R26AA

FINAL NOTICE

DATE: August 27, 2026
TO: Blue Bird Owners
Subject: R26AA: Improper Window Markings on Lippert Windows

SUBJECT: R26AA: Improper Window Markings on Lippert Windows

Fig. 3

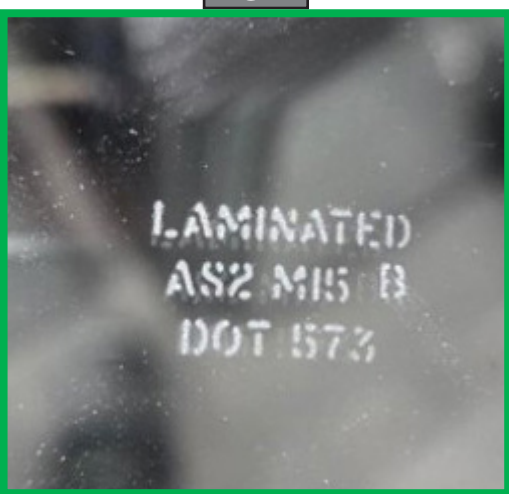
- Visually inspect the upper and lower glass of each bus window. Look for the DOT logo.
 - Sash Window - Correct (Fig. 1)
 - Sash Window - Incorrect (Fig. 2)
- Note each window where the DOT logo is not compliant (Fig. 2).
 - Driver's Window - Correct (Fig. 3)
 - Driver's Window - Incorrect (Fig. 4)

Fig. 8

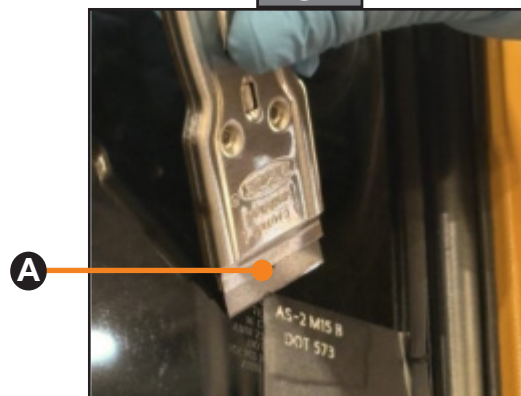
1. Liberally apply the etching compound to the lettering portion by squeezing the bottle and tapping the lettered area of the stencil (Fig. 8).
2. Let the compound stand for 1 minute and reapply.
3. Let the reapplied etching compound stand for 5 minutes. Remove the excess compound with lukewarm water and a clean soft cloth.
